[1] REDLINE REVISION
February 9, 2005

MARYLAND DOT - STATE HIGHWAY ADMINISTRATION
Office of Traffic & Safety
TRAFFIC ENGINEERING DESIGN DIVISION
(Traffic Signal Plan)
MD 586 (Veirs Mill Road) at Reedie Drive/Wheaton Plaza North Entrance

DRAWN BY: Carlos Buitrago	F.A.P. NO. N/A	TS NO. 2441-A	SHEET NO.
CHECKED BY: Farshad Bigdeli	S.H.A. NO. BW996M82		
SCALE: 1" = 20'	COUNTY: Montgomery	T.I.M.S. NO. G-383	3 OF 8
DATE: May 6, 1988	LOG MILE: 15058605.55

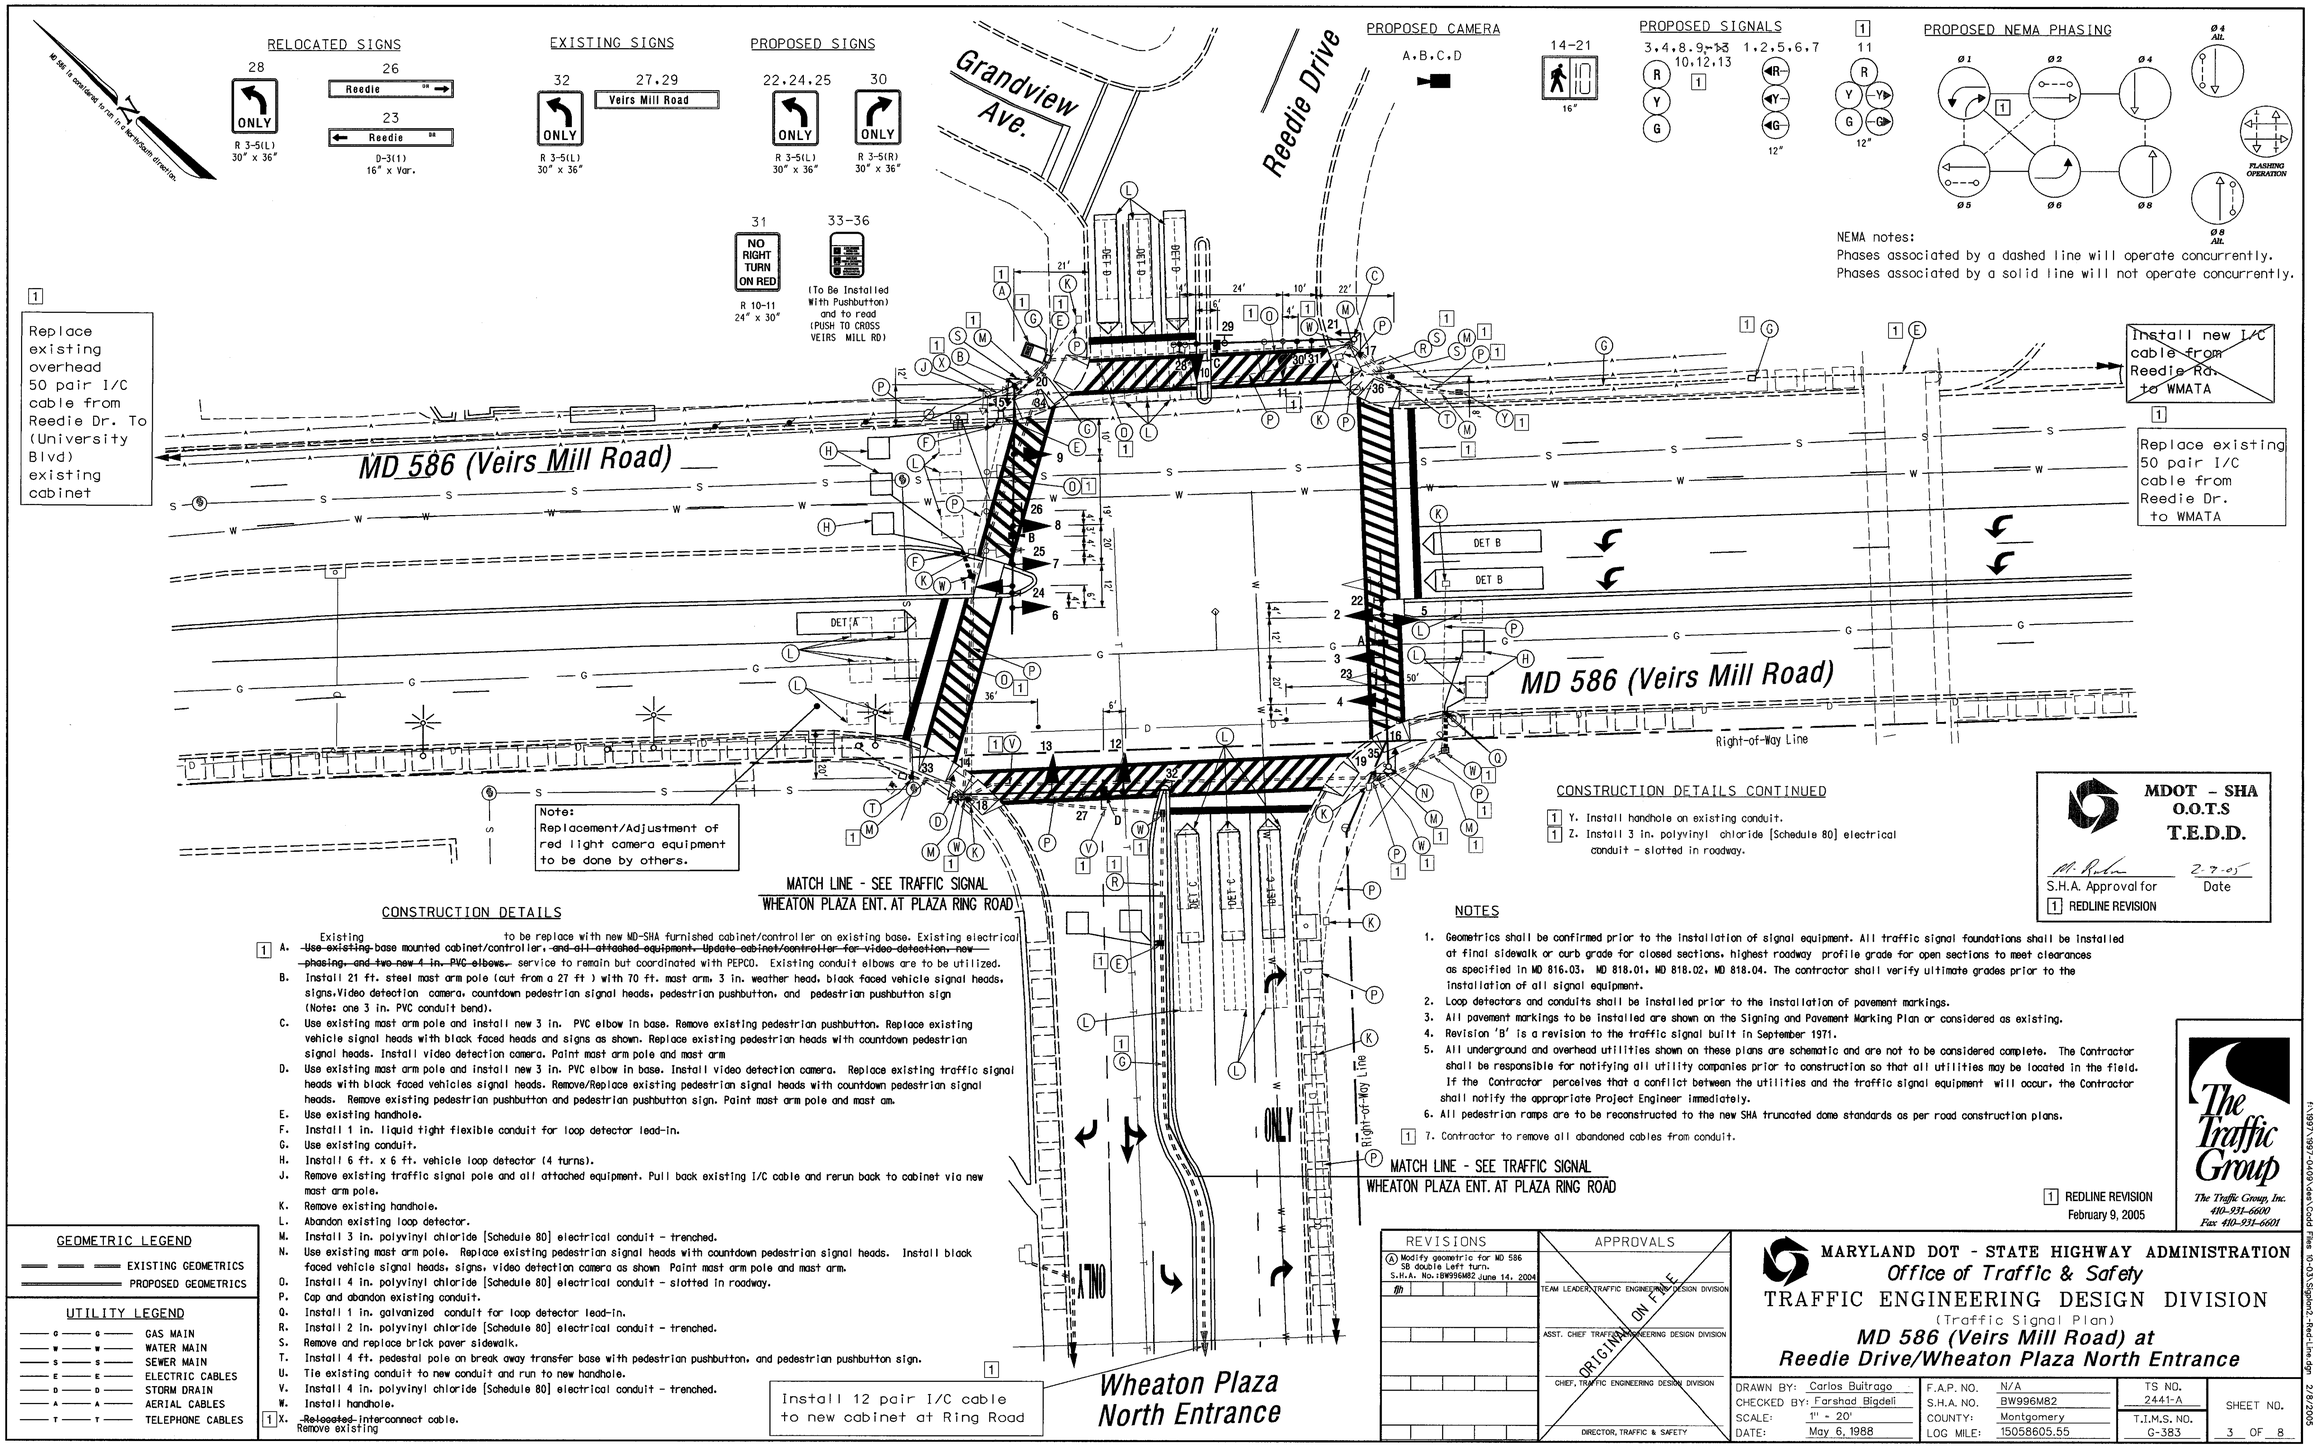
[1] A. Existing to be replace with new MD-SHA furnished cabinet/controller on existing base. Existing electrical ~~Use existing~~ base mounted cabinet/controller, ~~and all attached equipment. Update cabinet/controller for video detection, new phasing, and two new 4 in. PVC elbows.~~ service to remain but coordinated with PEPCO. Existing conduit elbows are to be utilized.

[1] X. ~~Relocated~~ interconnect cable. Remove existing

[1] Y. Install handhole on existing conduit.

[1] Z. Install 3 in. polyvinyl chloride [Schedule 80] electrical conduit - slotted in roadway.

6. All pedestrian ramps are to be reconstructed to the new SHA truncated dome standards as per road construction plans.
7. [1] Contractor to remove all abandoned cables from conduit.
